**Los Alamos**  
NATIONAL LABORATORY  
**memorandum**

To/MS: Memo to the File, OU 1129, MS M321  
From/MS: Gabriela Lopez Escobedo, CST-7, MS E525  
Phone/FAX: 5-7352/5-4632  
Symbol: EM/ER-RAFA: 98-111  
Date: June 16, 1998

**SUBJECT: SAP DOCUMENTATION FOR ADDITIONAL SAMPLING  
ACTIVITIES AT PRSs 04-003(u) AND 04-004**

Figure 1. Sample location map for PRS 4-003(a) and 4-004.

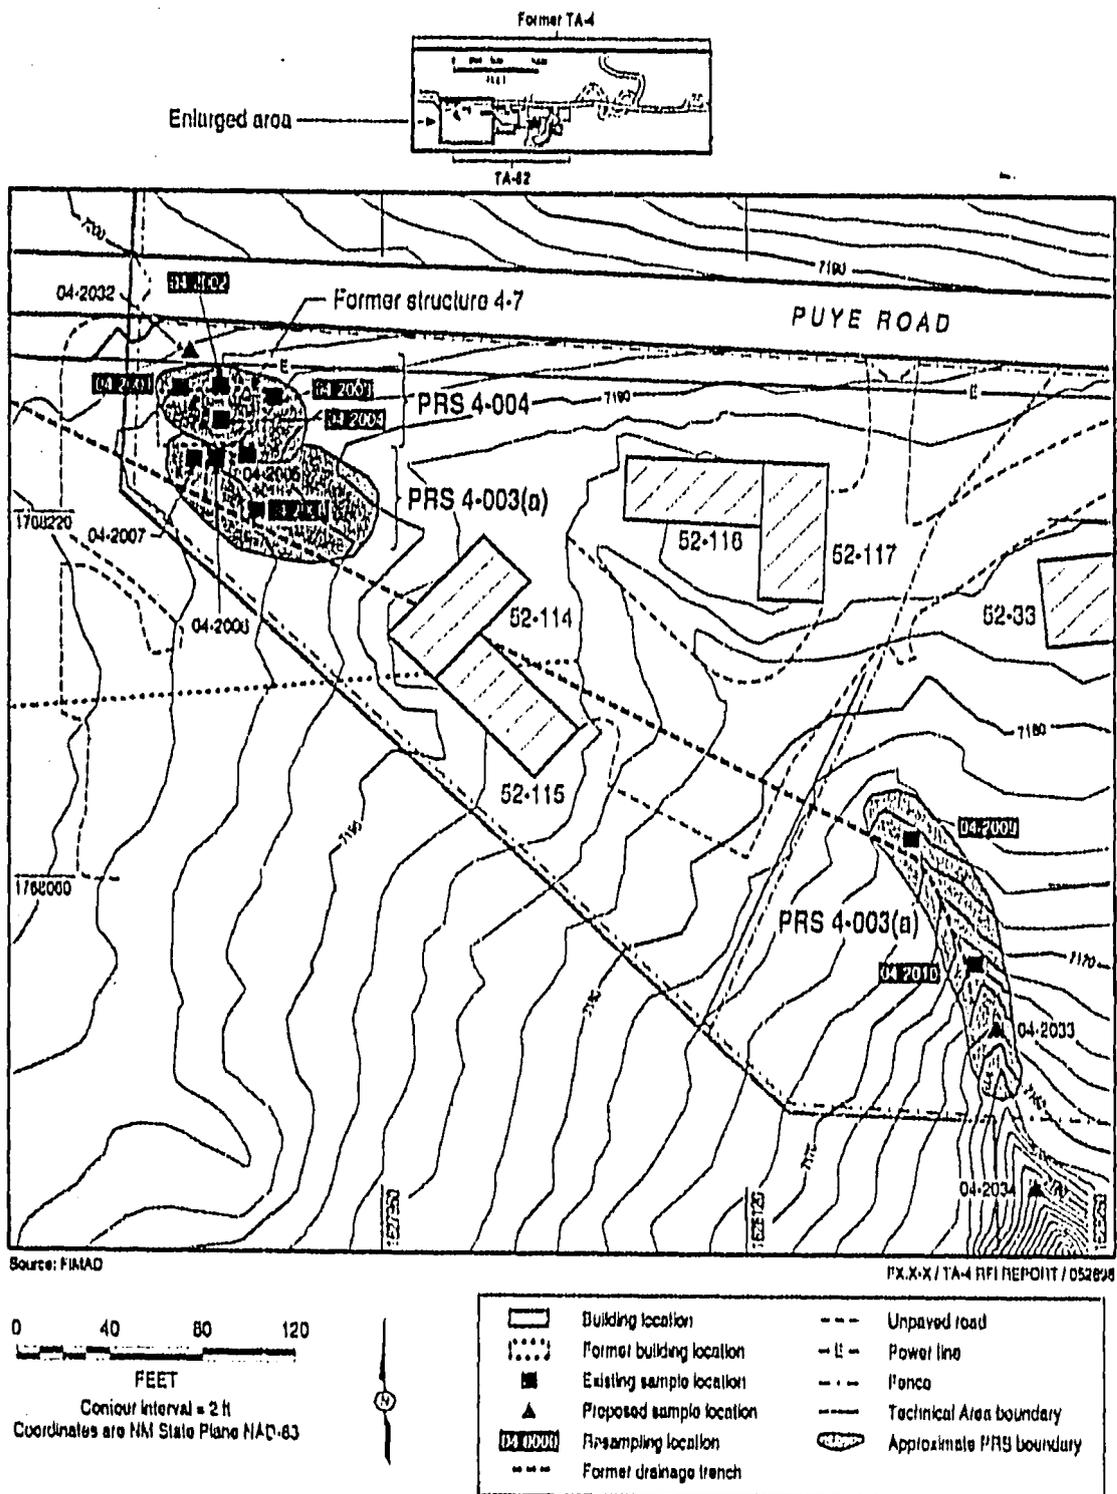
- Two sample locations (4-2033 and 4-2034) are being added to characterize the nature and extent of contamination. Samples will be collected from the 0- to 6-inch depth interval and every foot thereafter until tuff is encountered.
- Seven locations (04-2001, 04-2002, 04-2003, 04-2004, 04-2008, 04-2009, and 04-2010) will be resampled to obtain fixed-laboratory confirmation of mobile lab results and to fill data gaps.
- High explosives tests are being added to the analyses performed.

- One sample location (04-2032) is being added to extend the sampling area because of poor confidence as to the location of former building 4-7.

This sampling effort will include resampling at the surface and subsurface of the following locations: 04-2001, 2003, 2004, 2008, 2009, and 2010. Location 04-2002 will be resampled only in the subsurface. These samples will be analyzed for metals, VOCs, SVOCs, and high explosives. Radiological analyses for these locations were obtained in Phase I.

Two new locations, based on field geomorphic evaluation of sediments (Davenport 1998, 58092), will be sampled at the surface and subsurface. One location will be to the north of the mapped location of former building TA-4-7, but inside the current TA-52 fence, in order to provide confirmatory data for the accuracy of that location. The other new sample location will be in the most likely historic sediments in the lower outfall drainage, below location 04-2010. Locations of these two samples are shown on the map in Figure 1. All locations will be sampled in the 0- to 6-inch depth interval and at 1-foot intervals thereafter until the soil/tuff interface is reached. Location IDs, depths, and analyses to be performed for all samples are shown in Table 3. The actual number of samples and depths will vary depending upon the depth to the soil/tuff interface.
